Project 171.05027.008

RE: Response to Review Comments  
Nordic Aquafarms Inc., Land-based Aquaculture Facility  
Belfast, Maine  
L-28319-26-A-N

This letter provides responses to the Department of Environmental Protection letter from Kevin Martin to Elizabeth Ransom dated July 3, 2019. For clarity, the entire comment from the letter has been copied below and italicized. Responses are in regular text, and on the attached plans and figures as referenced below.

PROJECT MANAGER:	ADB	PROJECT NO.:	18076
A/E OF RECORD:	MGJ		
JOB CAPTAIN:	SP		
DRAWN BY:	WSM		
SMRT FILE:	CP105-18076	SHEET No.:	<b>CP105</b>

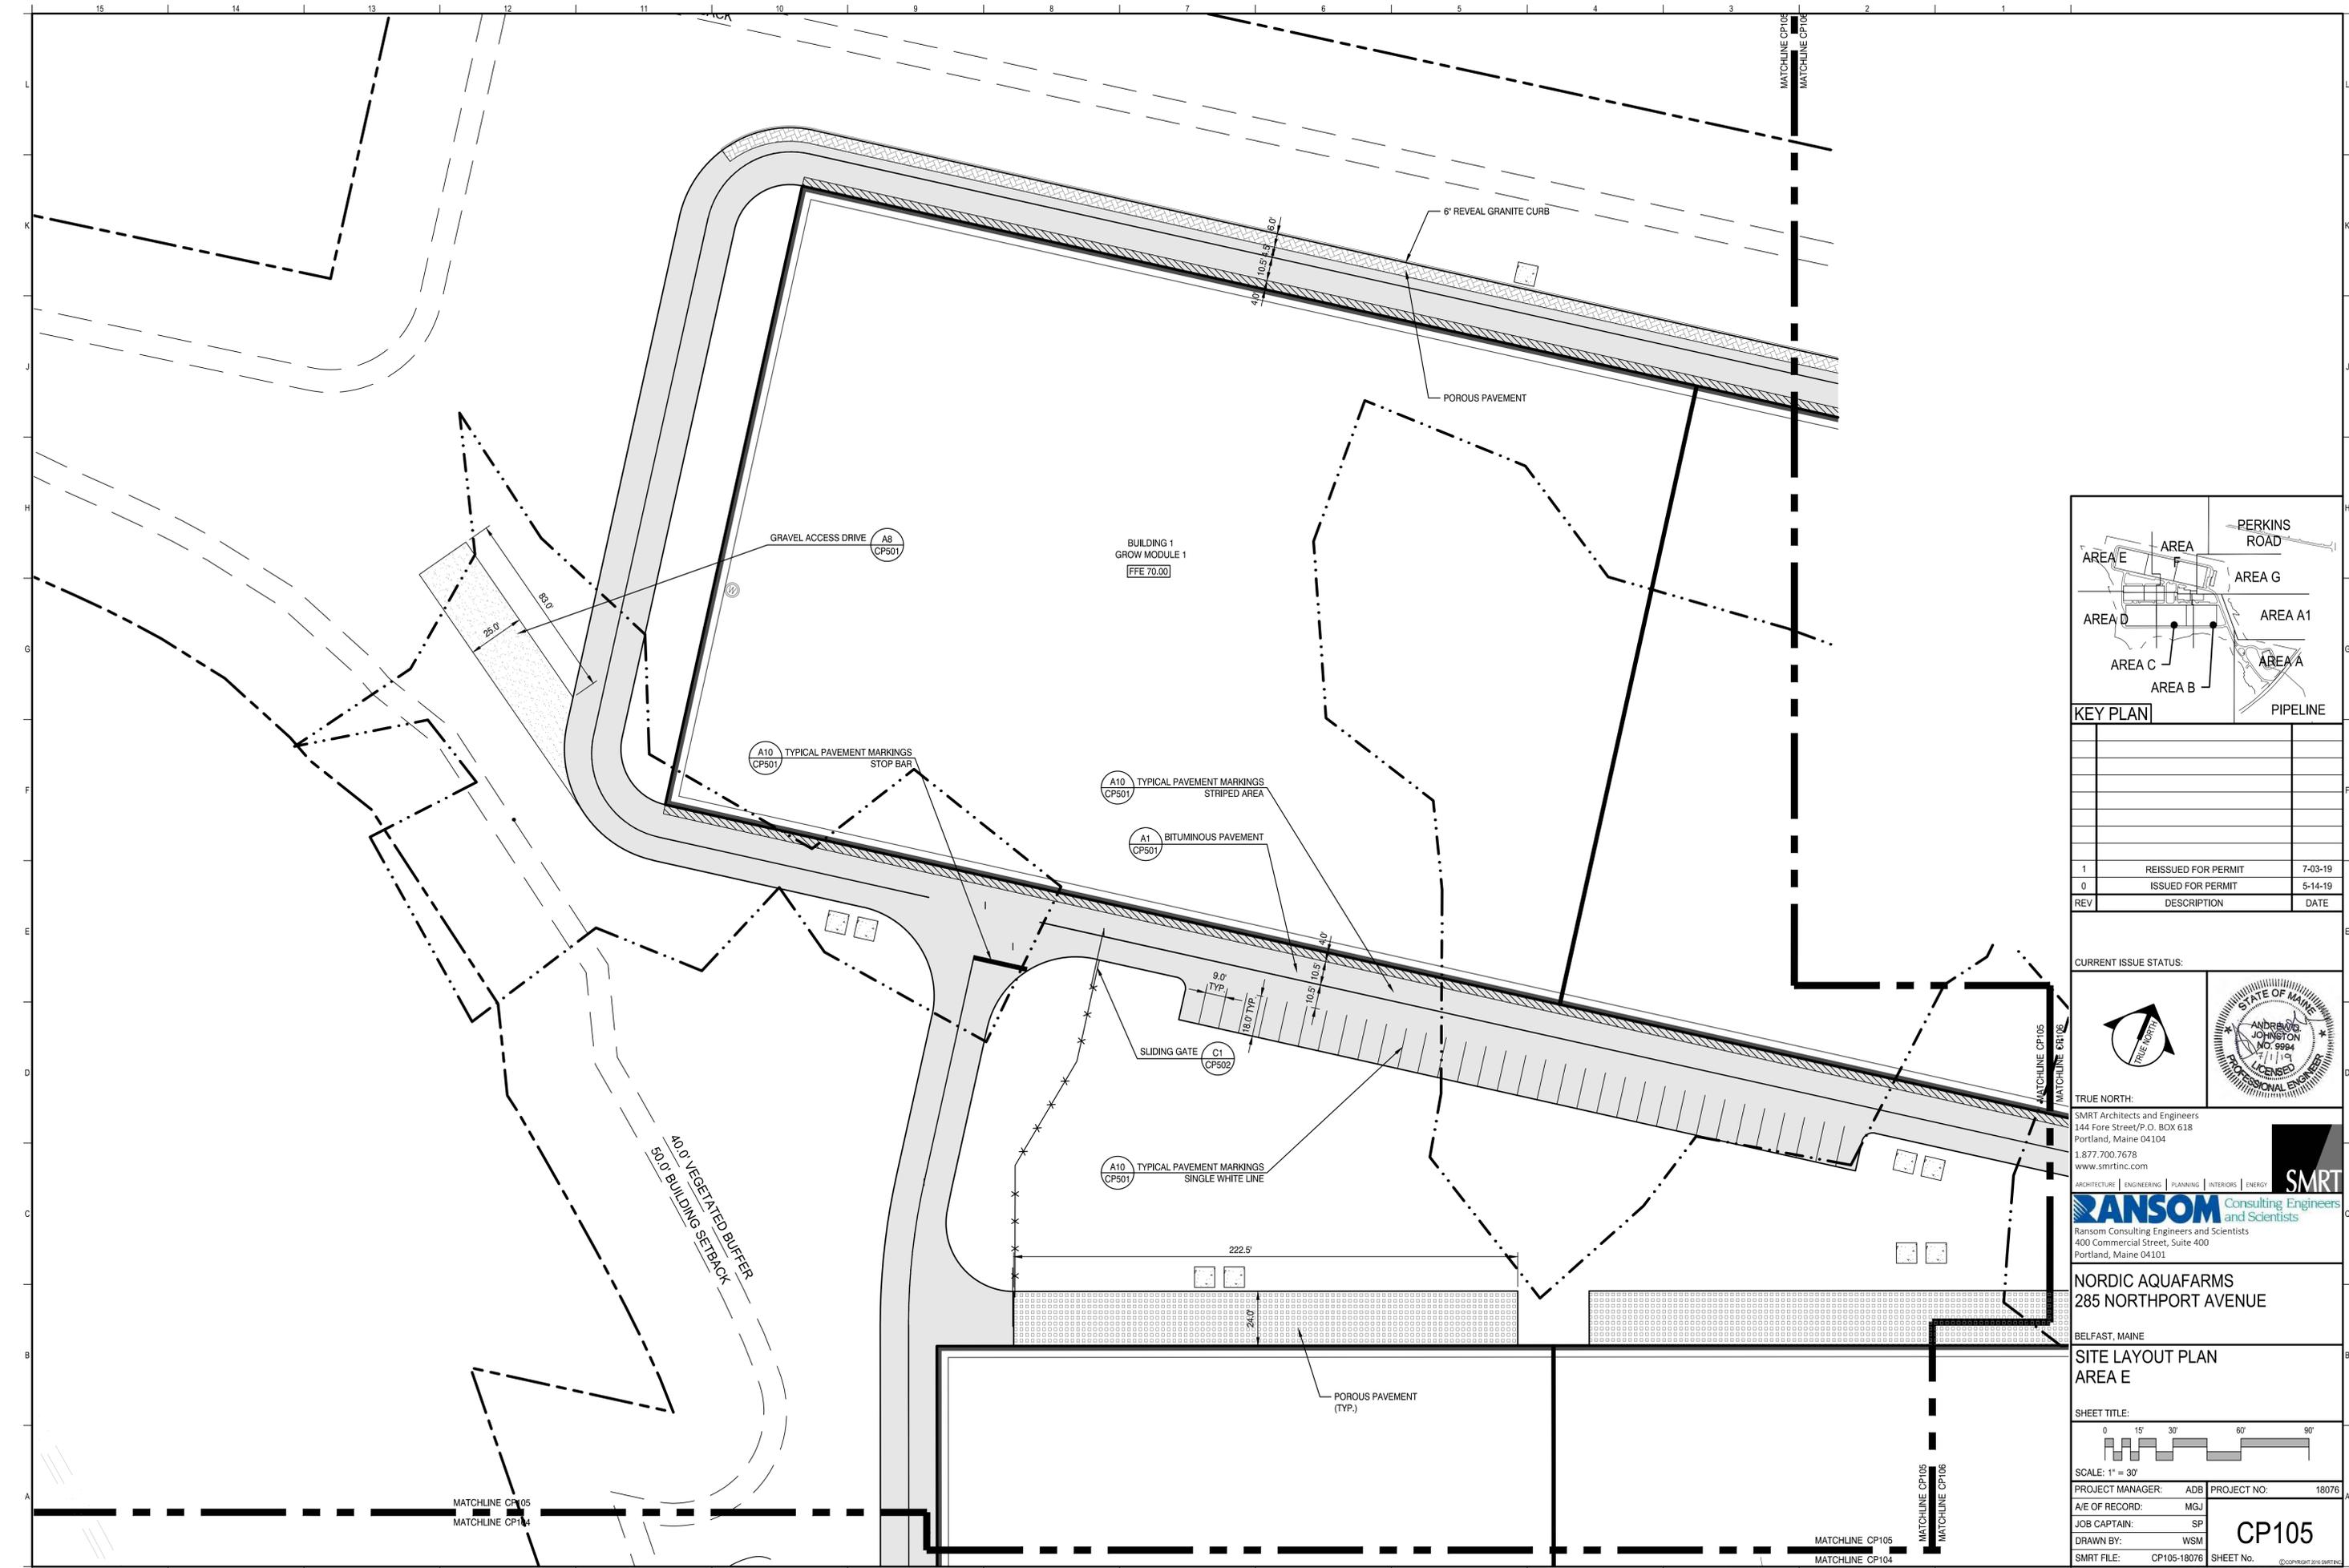
*9. With regard to Drawing CP105, please describe the purpose of the proposed gravel access driveway in the upper left portion of the drawing, near the west end of Building 1. Could it be removed or relocated outside of the wetland to reduce impacts?*

The additional gravel access driveway can be removed. A revised drawing CP105 is included as **Attachment F**.

SCALE: 1" = 30'	PROJECT MANAGER: ADB	PROJECT NO: 18076
A/E OF RECORD:	JOB CAPTAIN: SP	<b>LP101a</b>
DRAWN BY: WSM	SMRT FILE: LP101a-18076

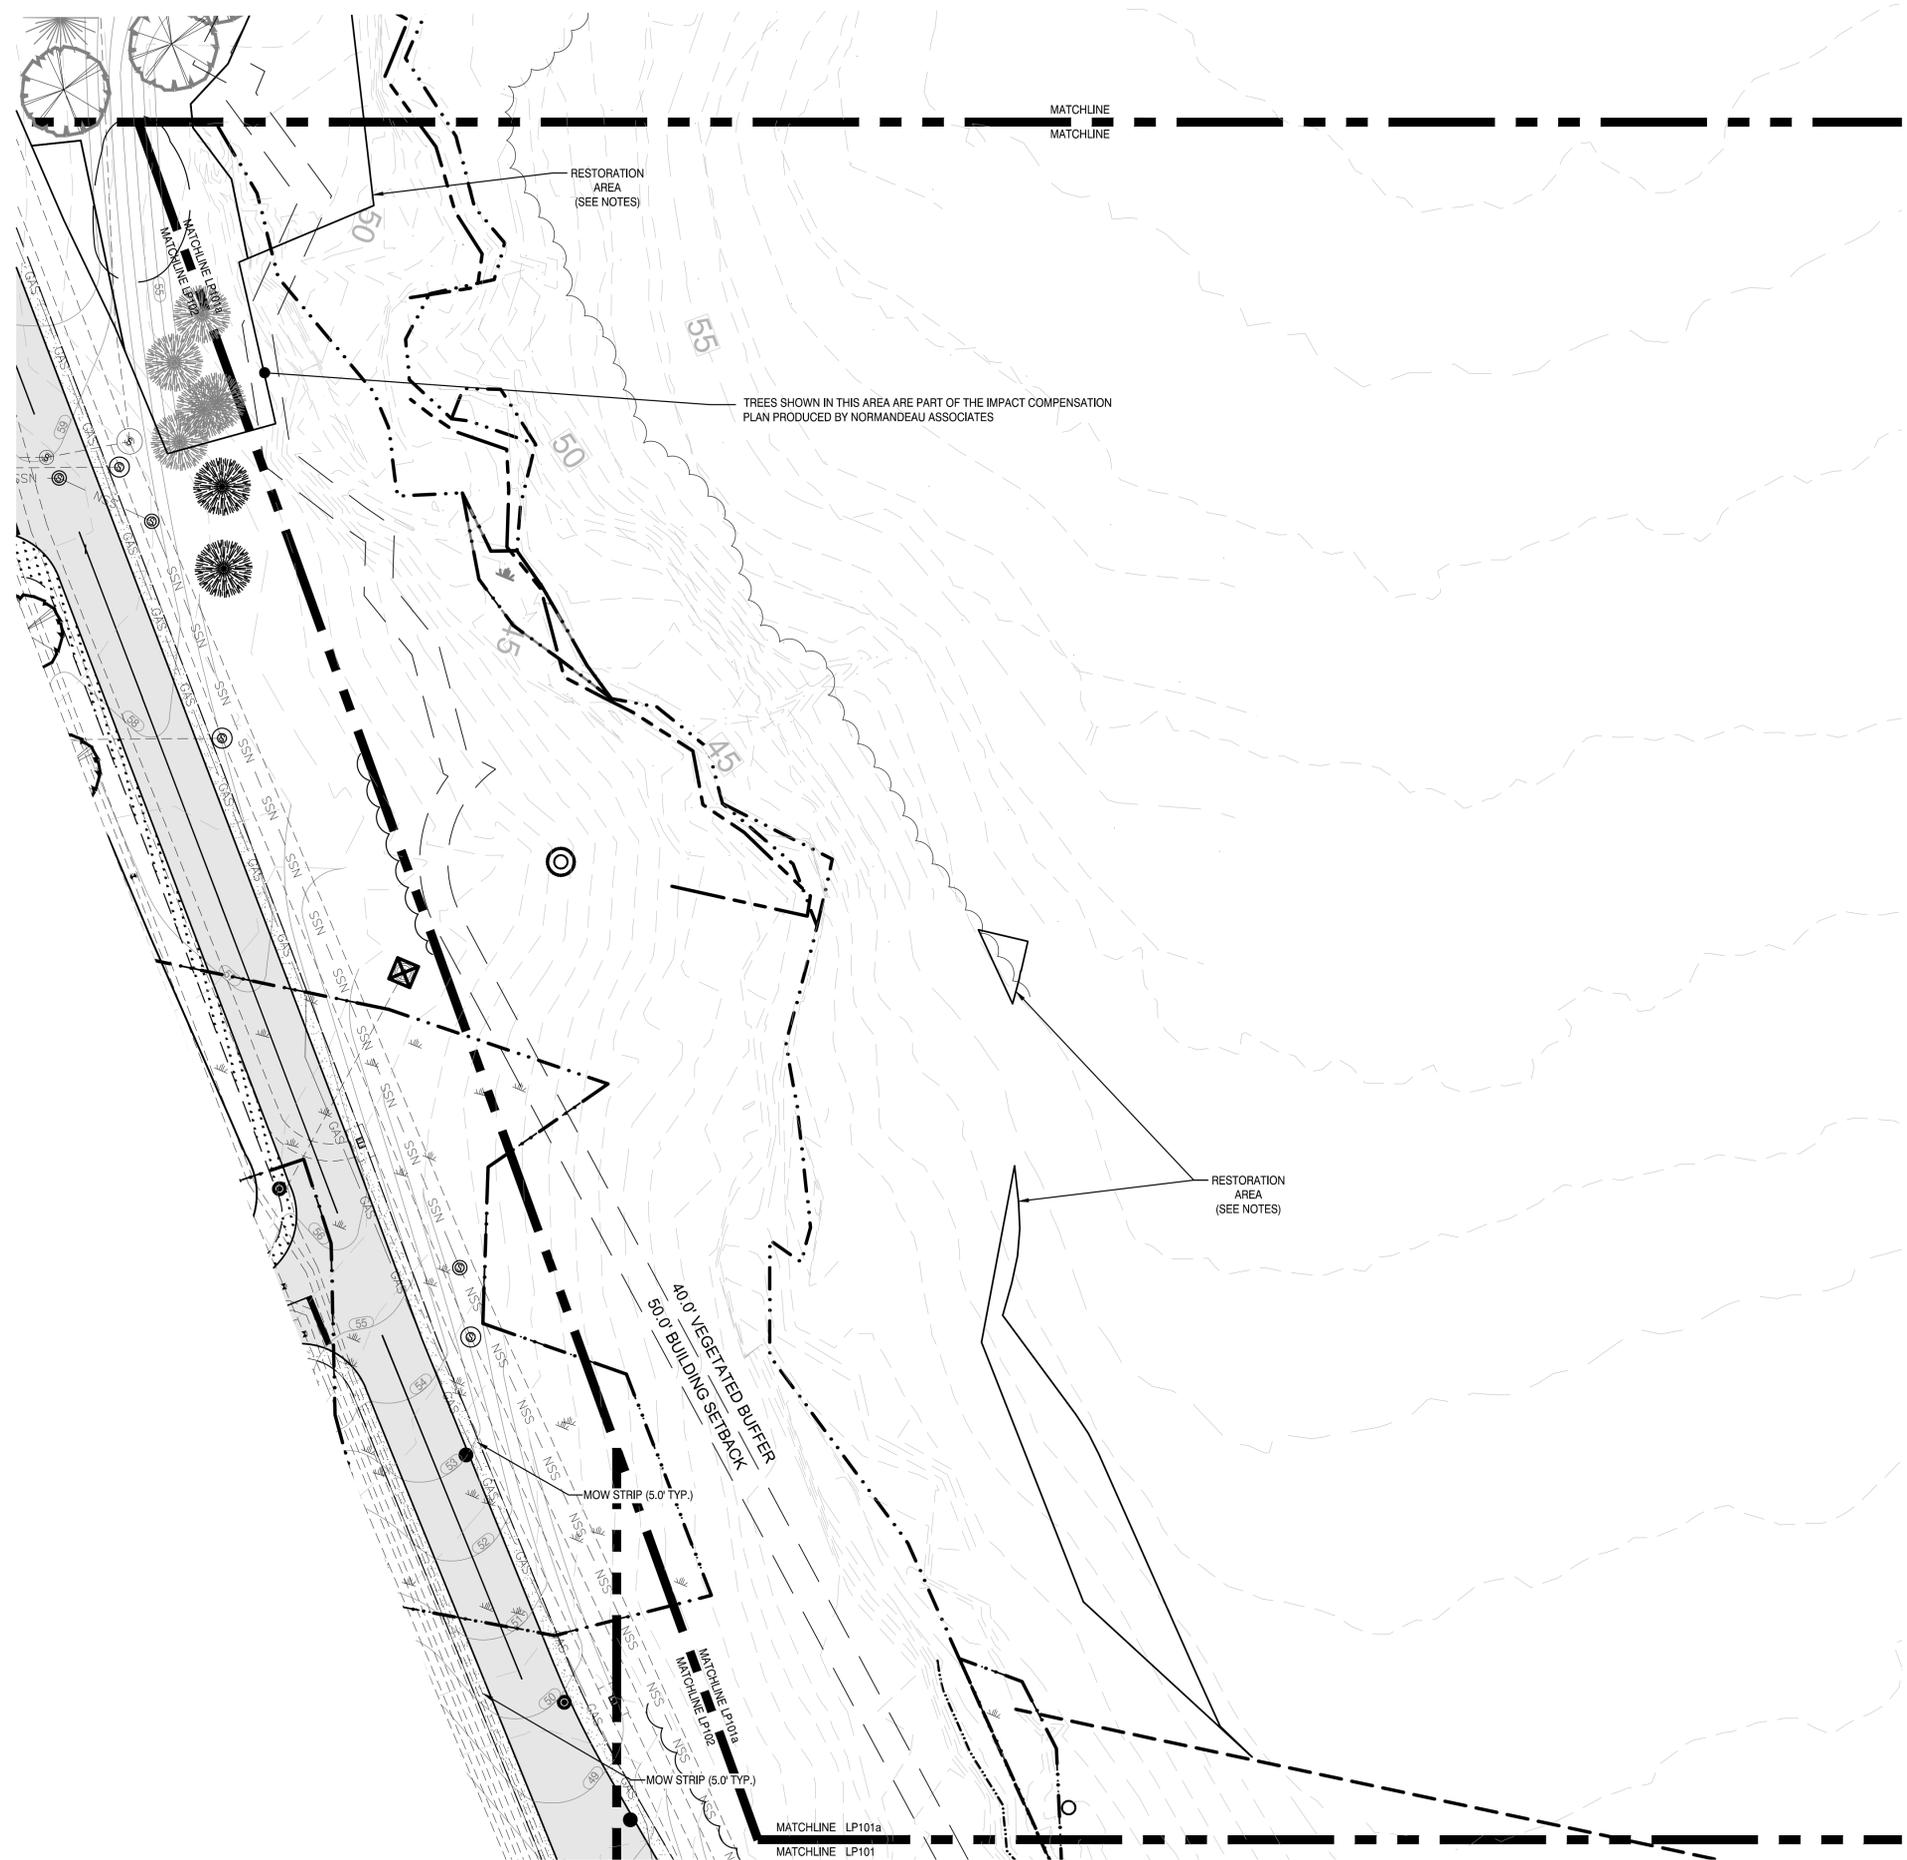
*12. Please provide a copy of the missing planting plan for Area A1 to insert among the other area planting plans in Attachment 13 of the NRPA application.*

Drawing LP101a (Area A1) was not included as an appendix to the Compensation Plan because LP101a only references "restoration area" polygons which refers to the Compensation Plans (**Attachment E**). For a clearer distinction between the restoration plantings and general landscaping, project landscaping plans (LP#### plans) have been updated to remove call outs on restoration area plantings and include notes to refer to separate restoration area plans for details. Updated landscaping plans (LP101, LP101a, LP102, LP107, and LP501) have been included as **Attachment I**.
